HISTORIC AND DESIGN REVIEW COMMISSION

December 20, 2017

HDRC CASE NO: 2017-635
ADDRESS: 705 N PINE ST
817 NOLAN
LEGAL DESCRIPTION: NCB 549 BLK 9 LOT S 83.5 FT OF 7 & 8
NCB 549 BLK 9 LOT 5&6
ZONING: IDZ, R-6, H
CITY COUNCIL DIST.: 2
DISTRICT: Dignowity Hill Historic District
APPLICANT: Guadalupe I & Willie A Francois
OWNER: Guadalupe I & Willie A Francois
TYPE OF WORK: Fencing, driveway modifications, gazebo installation
APPLICATION RECEIVED: November 29, 2017
60-DAY REVIEW: January 28, 2018
REQUEST:

PLAN

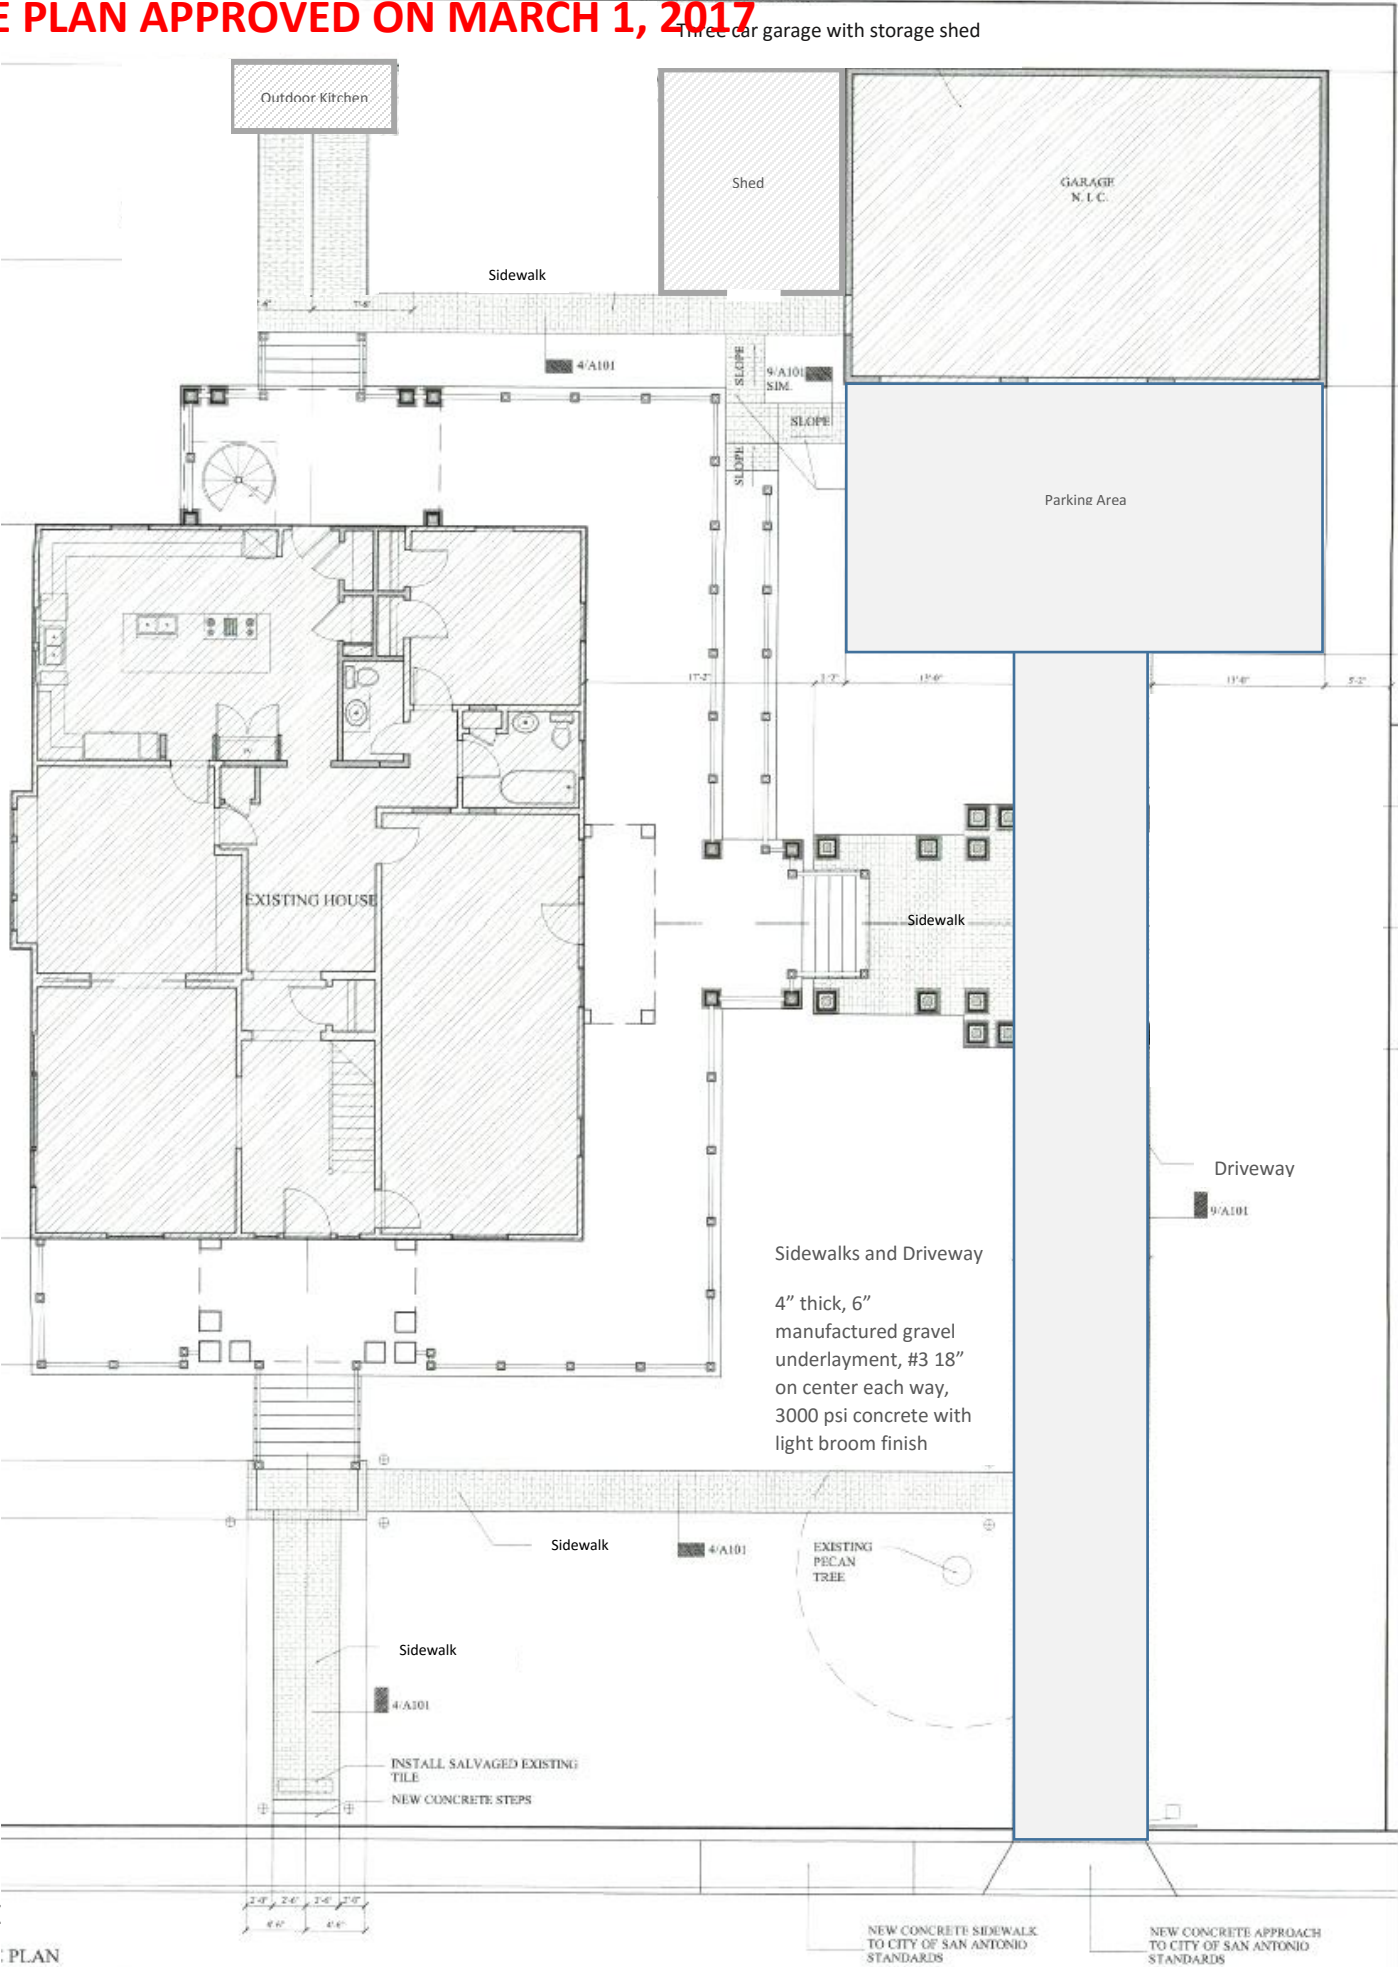
- e. **DRIVEWAY** – The applicant has proposed to install a driveway to feature an initial width of fourteen (14) feet to taper to ten (10) feet in width that will feature a slight curve. At the March 1, 2017, HDRC hearing, the applicant proposed a straight driveway. The Guidelines for Site Elements 5.B.i. notes that driveways in historic districts typically do not exceed ten (10) feet in width. Additionally, the Guidelines note that new driveways should be similar to those found historically in the district in regards to their materials, width and design. Staff finds that a tapered, curved driveway is not consistent with the Guidelines. Staff finds that the applicant should install a straight driveway that features ten (10) feet in width.

- f. **BRICK PAVERS** – The applicant has proposed to install brick pavers beneath two mature pecan trees where concrete was previously approved to remove the ability for tree roots to displace the concrete. Staff finds this request to be appropriate.

Staff does not recommend approval of items #1 through #3, the proposed fencing modification, installation of a prefabricated, metal gazebo and driveway modifications based on findings c, d and e. Staff finds that the previously approved fence with wood posts and rails as well as a straight driveway to feature ten (10) feet in width to be appropriate.

Staff recommends approval of item #4, the installation of brick pavers beneath two mature pecan trees to replace previously approved concrete.

PROPOSED METAL GAZEBO

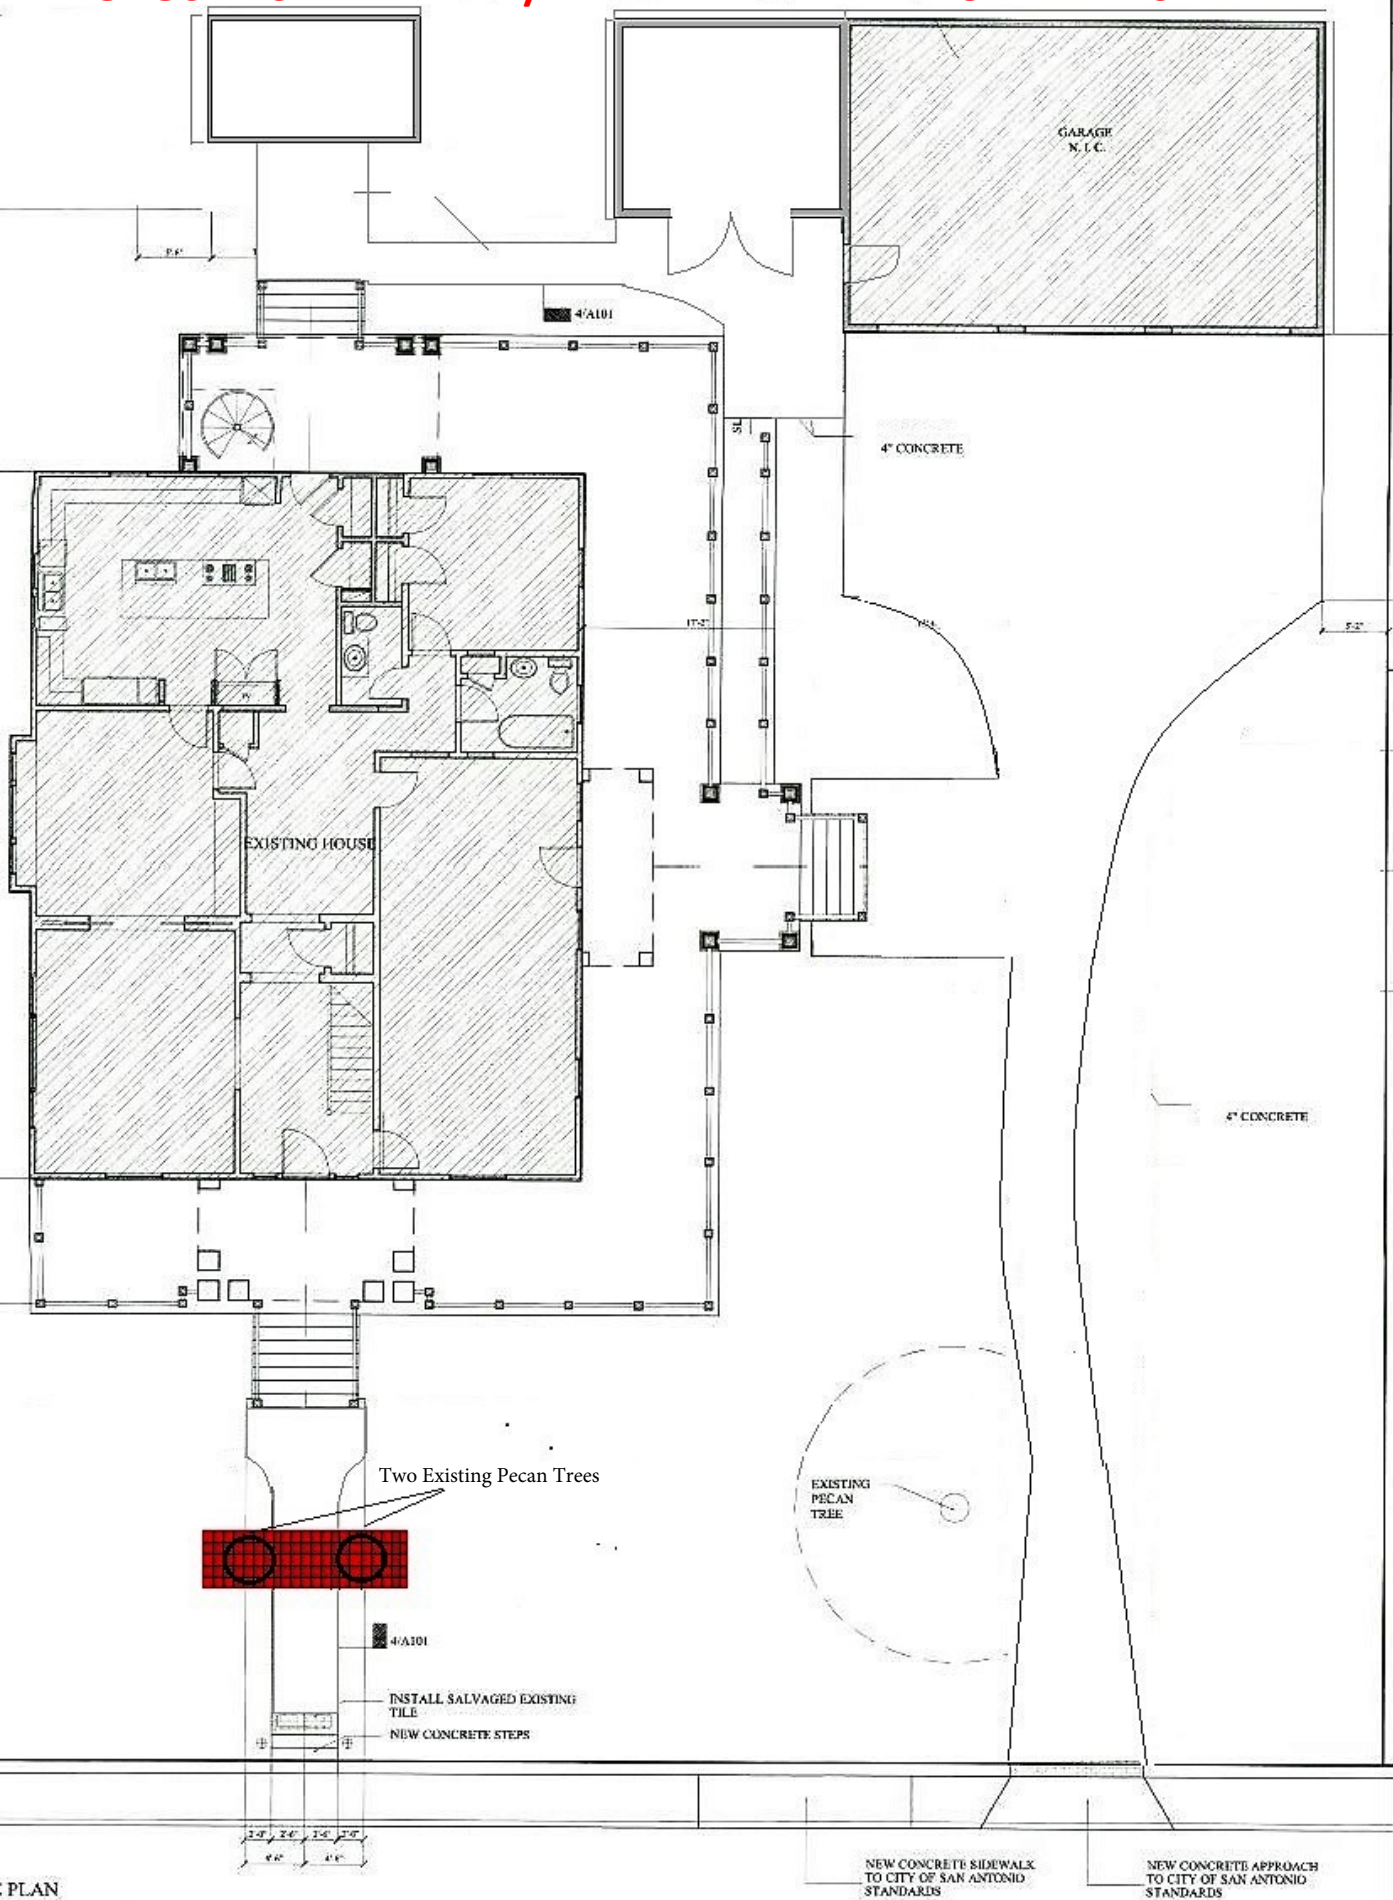
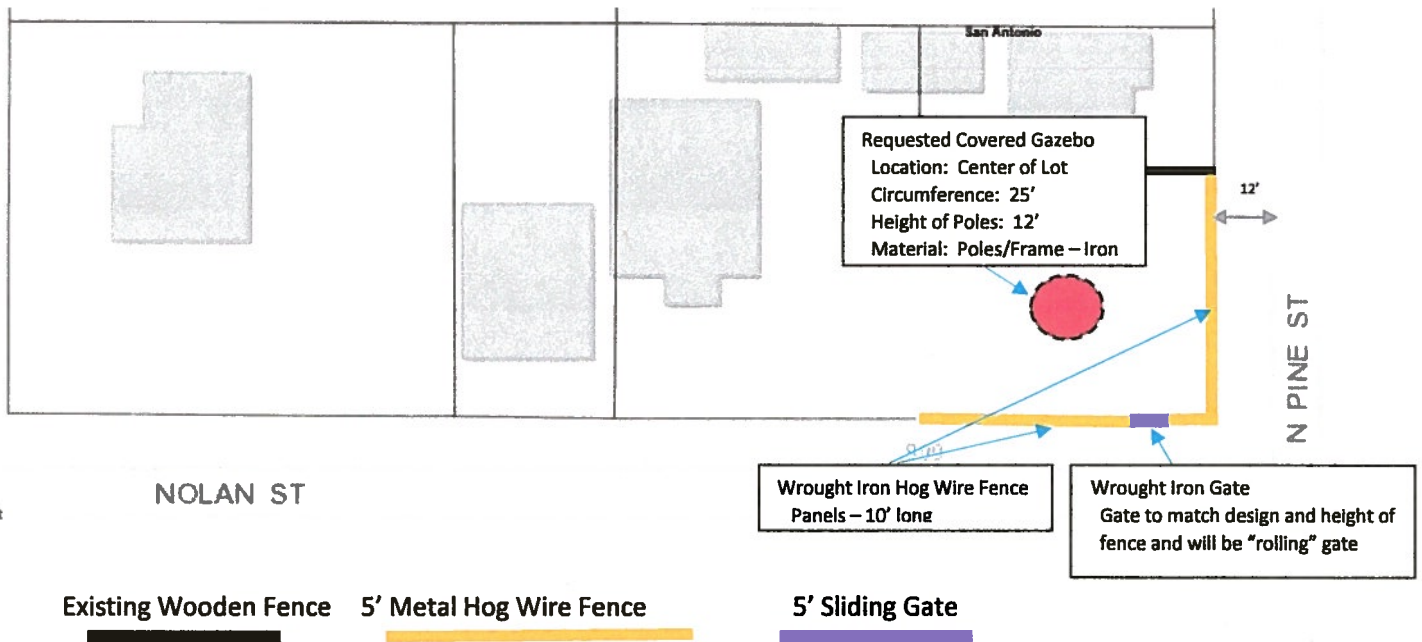
- d. **GAZEBO** – The applicant has proposed to install a prefabricated, metal gazebo on the vacant lot at 705 N Pine, the lot at the corner of N Pine and Nolan. The Guidelines for New Construction 5.A. notes that new accessory structures should relate to the period of construction of the principal building on the lot through the use of complementary materials and simplified architectural details. Staff does not find the use of metal to be appropriate for the proposed structure. Metal is not a building material found historically throughout the Dignowity Hill Historic District.

PROPOSED METAL FENCING

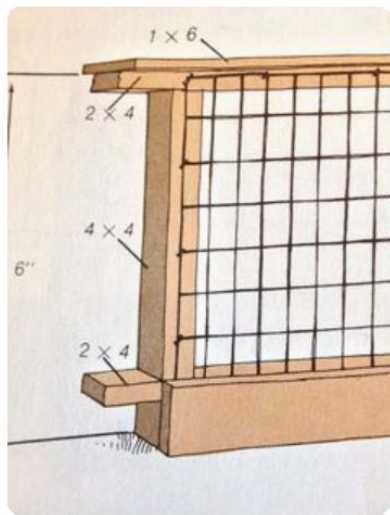
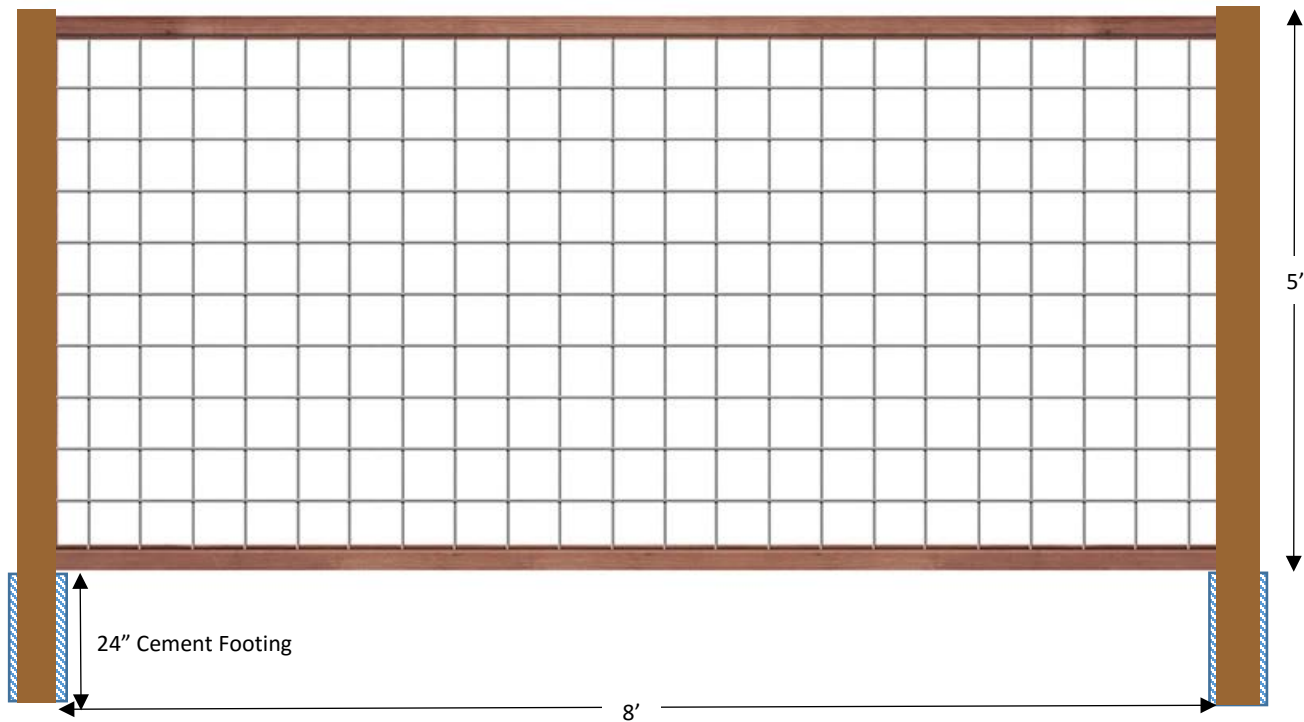
- c. **FENCING** – The applicant has proposed to amend the previously approved COA for cattle panel fencing to feature wood posts and rails for metal posts and rails. Per the Guidelines for Site Elements 2.A.i. notes that new fencing should appear similar to those used historically throughout the district in terms of their scale, transparency and character. Wood fences are found commonly throughout the Dignowity Hill Historic District; both in the form of wooden picket fences and cattle panel fences. A cattle panel fence that features metal posts and rails is a fencing detail commonly found on commercial or industrial properties. Staff finds the originally approved, wood fencing to be appropriate.
